UNITED STATES PATENT AND TRADEMARK OFFICE

APPLICATION NO.	FILING DATE	FIRST NAMED INVENTOR	ATTORNEY DOCKET NO.	CONFIRMATION NO.
10/699,284	10/31/2003	Daniël C. Worledge	YOR920030410US1	2560
7590 07/12/2005				
Ryan, Mason & Lewis, LLP Suite 205 1300 Post Road Fairfield, CT 06824			EXAMINER NGUYEN, THINH T	
			ART UNIT 2818	PAPER NUMBER

Office Action Summary

DETAILED OFFICE ACTION

FIG. 1

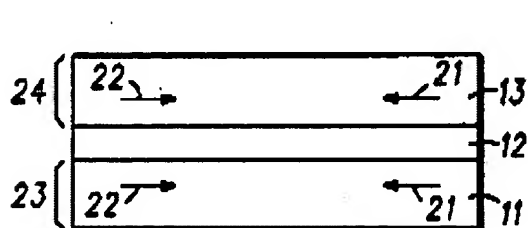
Zhu discloses (in the abstract, in fig 1) a semiconductor device comprising: at least two magnetic layers; and a spacer layer formed between the magnetic layers, the spacer layer being configured to provide ferromagnetic exchange coupling between the layers, the magnetic layers experiencing anti-ferromagnetic dipole coupling, such that a net coupling of the magnetic layers is anti-ferromagnetic in a zero applied magnetic field.

Zhu discloses (in the abstract, in fig 1) a method for coupling magnetic layers in a semiconductor device comprising at least two magnetic layers and a spacer layer therebetween, the method comprising the step of providing ferromagnetic exchange coupling of the magnetic

layers, the magnetic layers experiencing anti-ferromagnetic dipole coupling, such that a net coupling of the magnetic layers is anti-ferromagnetic in a zero applied magnetic field.

**FIG. 2b****REGARDING CLAIM 10**

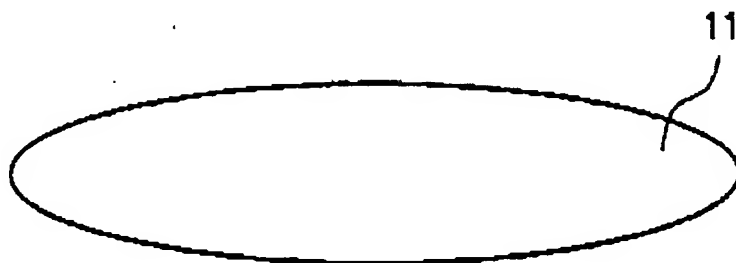
Zhu discloses all the invention except for the specific relative thickness of the two magnetic layers. This feature, however, is considered obvious since it has been held that when the general conditions of a claim are disclosed in the prior art discovering the optimum or workable range is of ordinary skill in the art.

Zhu discloses all the invention except for the uses of an elliptical or circular shapes; these features, however, are considered obvious since the use of elliptical or circular shape are old and well known in the art as evidenced by the disclosure by Deak (US patent 6,728,132) fig 2b.

A person skill in the art at the time the invention was made would be able to use the disclosures by Zhu and come up with the invention of claims 6,7 without special teachings.
